Comment on the Dominion Road Mixed-use Development Application

Watercare has reviewed the proposal in relation to the water and wastewater servicing for this development. Subject to the requirements below, we confirm that Watercare is able to provide water and wastewater services to the proposed **6-storey building with 118 Residential apartments, 4038 m² Retail units, 2,817m² Supermarket and associated car parking.**

The proposed extension to our networks are set out in the application, in particular, ROBERT BIRD GROUP 3-waters drainage plan drawing n^o N0263-RBG-ZZ-XX-DR-CV-86010/Rev P01 (EPA Appendix 13 - Infrastructure report appendix C - Engineering drawings) and the water and wastewater demand calculations included in the Infrastructure Report document n^o

GIS screenshot with the wastewater lines mentioned above highlighted in yellow.

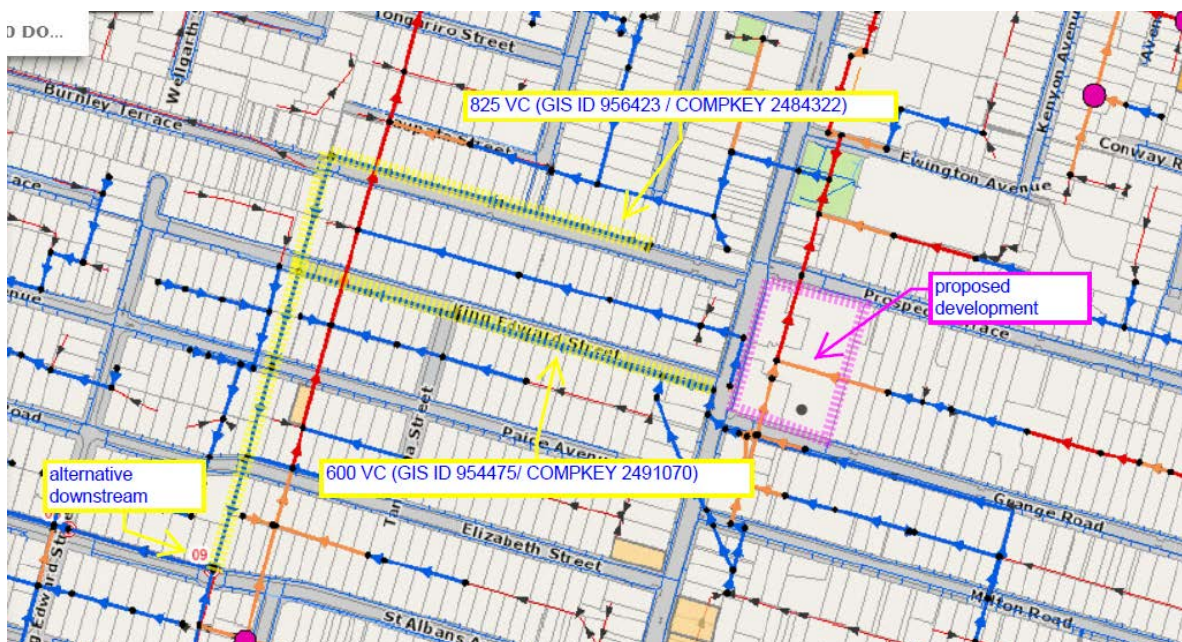
Watercare confirms that there is enough capacity in the network to supply this development by connecting the development to the 825mm VC line on Burnley Terrace or the 600mm VC on King Edward Street. Watercare has agreed that the proposed development can be connected to either of the combined lines (825mm or 600mm) shown in the diagram below rather than diverting the entire upstream catchment.

Screenshot of 3-waters drainage plan drawing n° N0263-RBG-ZZ-XX-DR-CV-86010/Rev P01

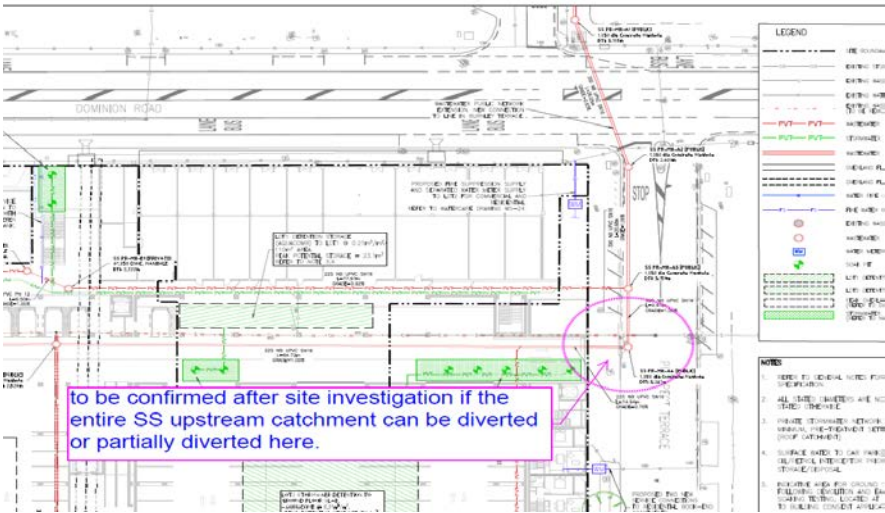
On the submitted 3-waters drainage plan drawing n° N0263-RBG-ZZ-XX-DR-CV-86010/Rev P01, it shows that they are proposing to divert the entire SS upstream catchment; however, this requires a further site investigation before we confirm that this will be acceptable. The connection to the 825mm can still proceed as per the current proposal but without capping the section/connection to the 225mm wastewater line on Prospect Terrace until the invert levels are confirmed.

Due to the absence of invert levels in GIS and recent asset survey data/results, it is not clear how the proposed upstream wastewater flow diversion will work hydraulically and whether there is enough gradient between the 225mm and the 825mm to connect appropriately. As the combined pipe (825mm) has a much larger diameter than the wastewater pipe (225mm), the connection of those pipes invert to invert can create potential backwater from the combined system to the wastewater system, which is not acceptable. Any proposal that may create a potential risk of backwater from a combined system to wastewater system must be reviewed and, if the risk or problem is identified, an alternative solution must be pursued.

The design and proposal must be based on actual site investigation. A CCTV inspection is required to confirm the wastewater line status, condition, invert levels and depths of the 825mm VC line or the 600mm VC before progressing with the design and the engineering plan approval (EPA).
